HILLTOP GEOTECHNICAL
INCORPORATED

Project No.: 1664-01
Report No.: 2

Subject: **Addendum Report in Response to Fault Hazard Report Review, Proposed Convenience Store and Fuel Canopies, APN: 0601-543-01, Avalon Avenue, Yucca Valley, San Bernardino County, California.**

Subject: Fault Hazard Report Review

Drawing Title:
Trench Log 1 of 3

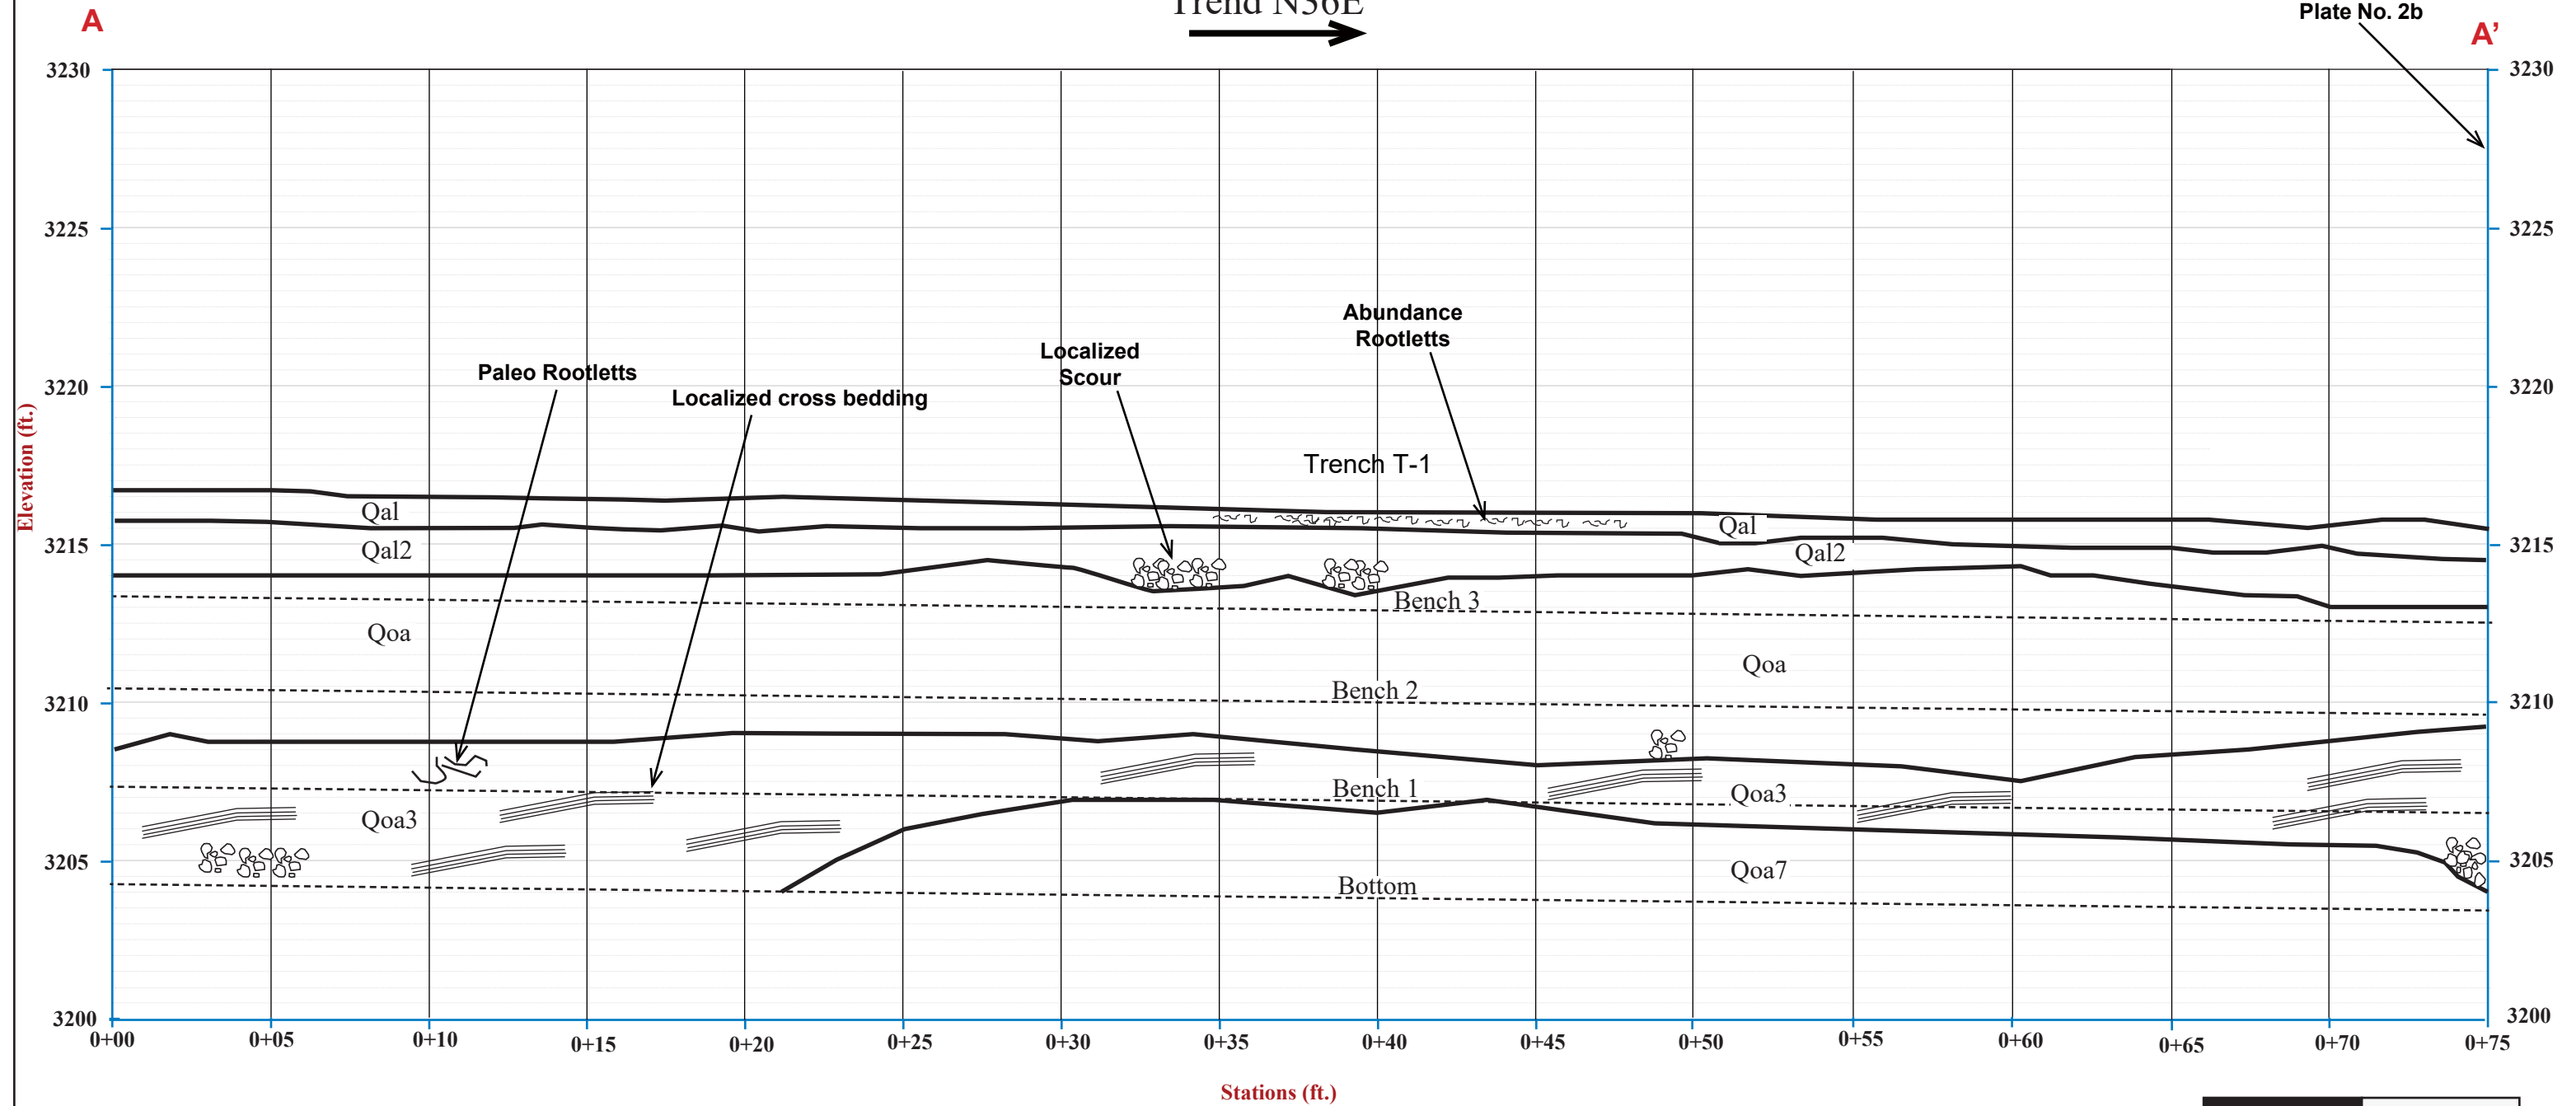
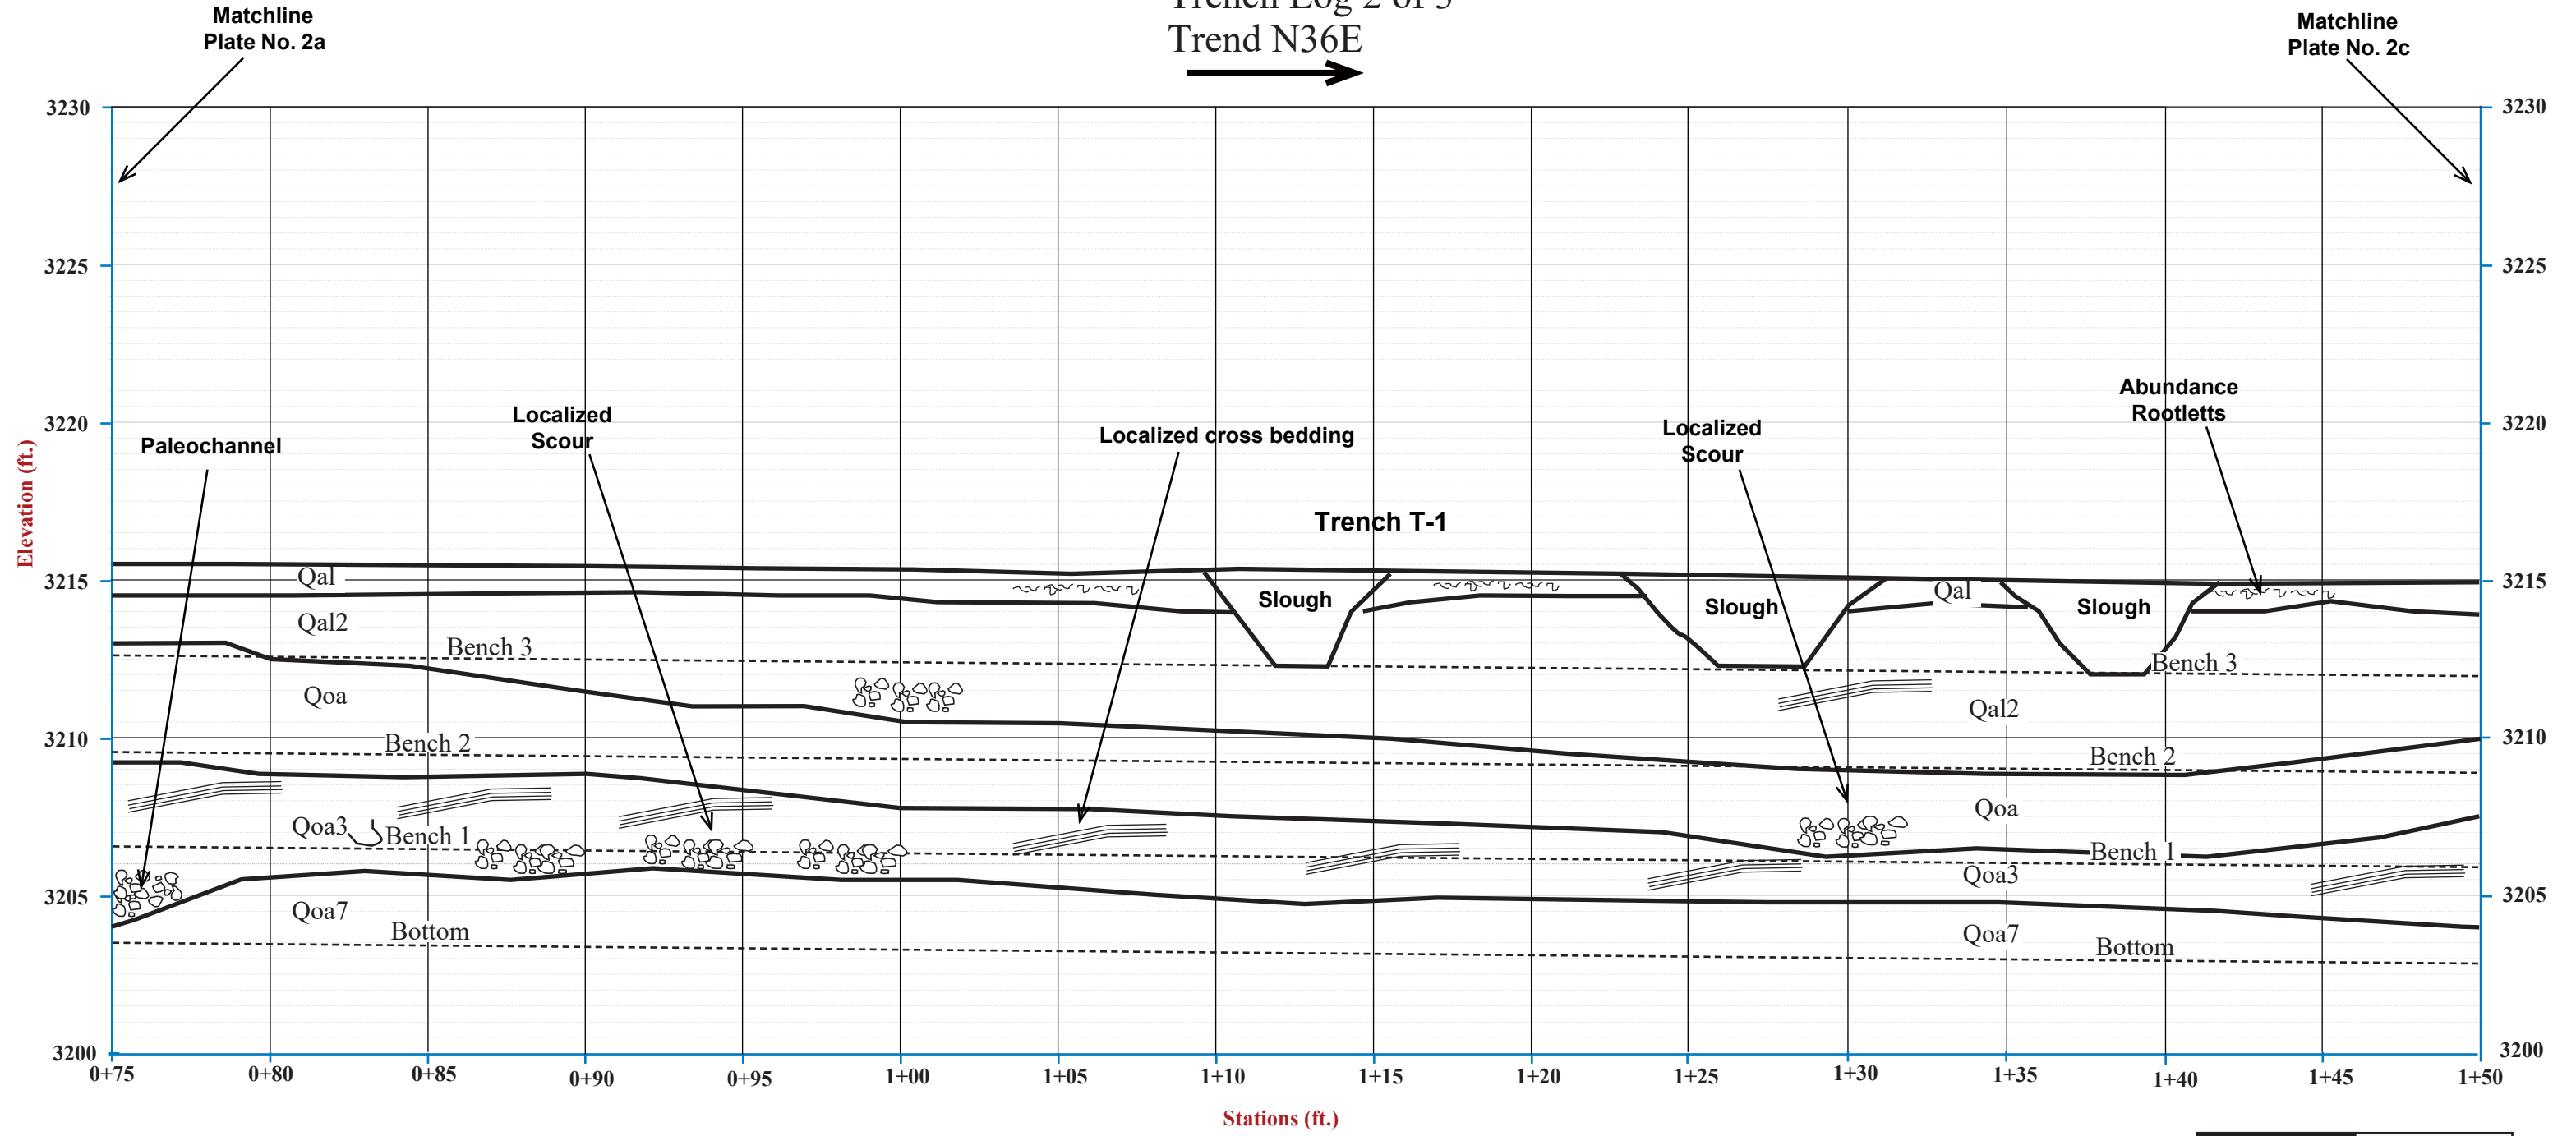
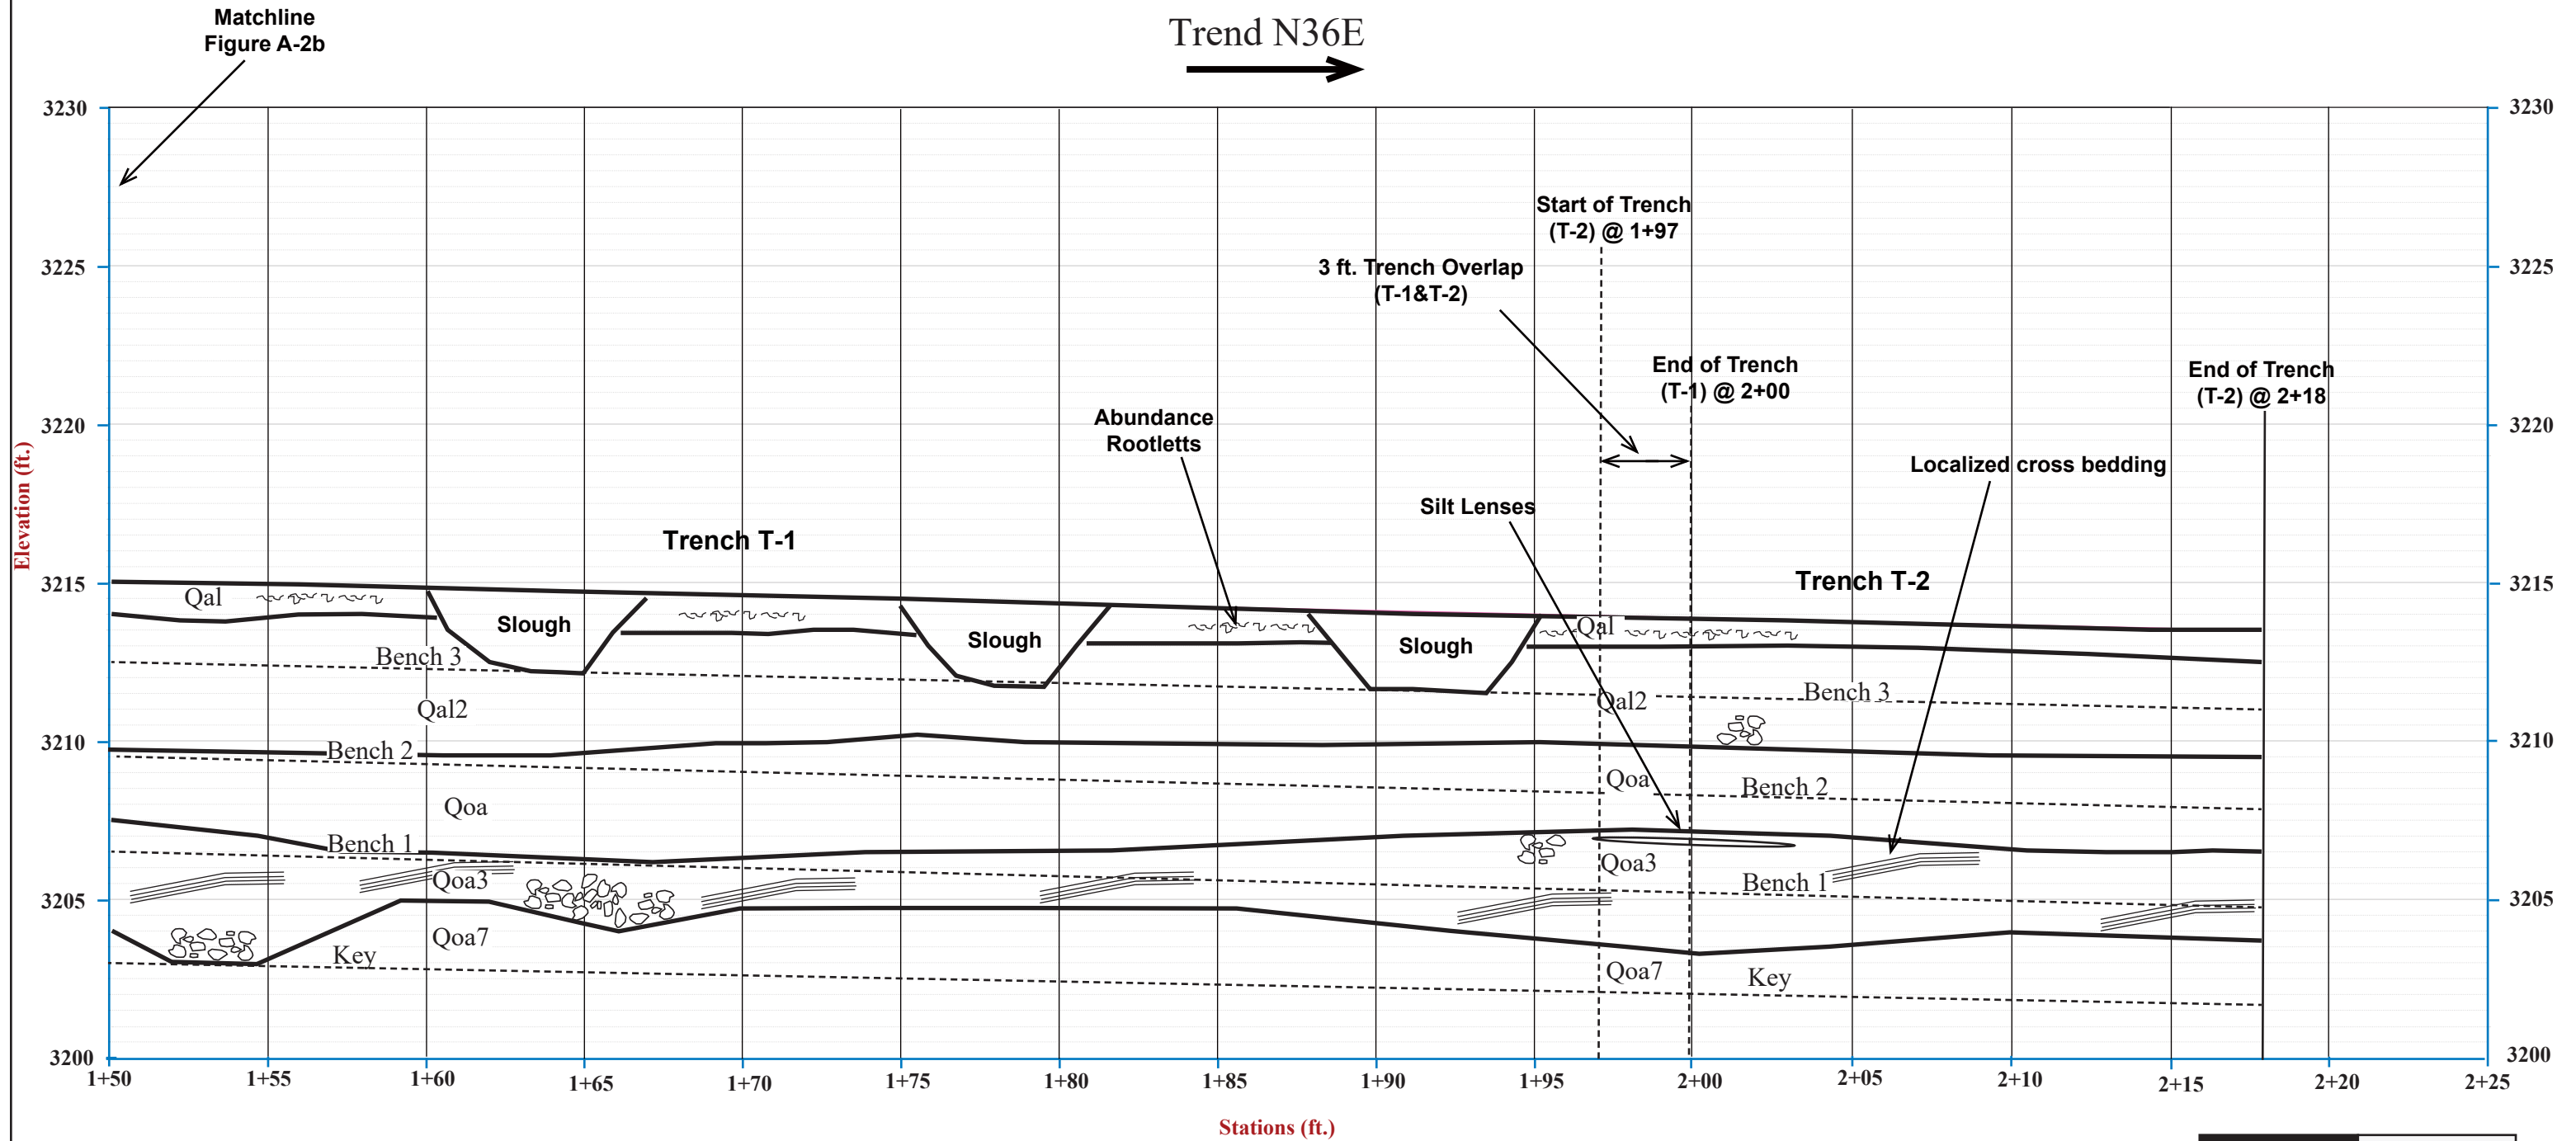
- a) The consultant states that approximately 213 feet of exploratory trench was excavated. However, the exploratory logs illustrate 218 feet. On page 9 the consultant states that two exploratory trenches had a total length of approximately 218 feet. Please provide clarification of the trench lengths. Please provide the trench log for trench T-2.

Trench T-2 log was showed at the east end of the fault trench profile in our fault hazard report. To clarify the fault trench profile, we also revised our fault trench logs to indicate an overlap of trenches T-1 and T-2.
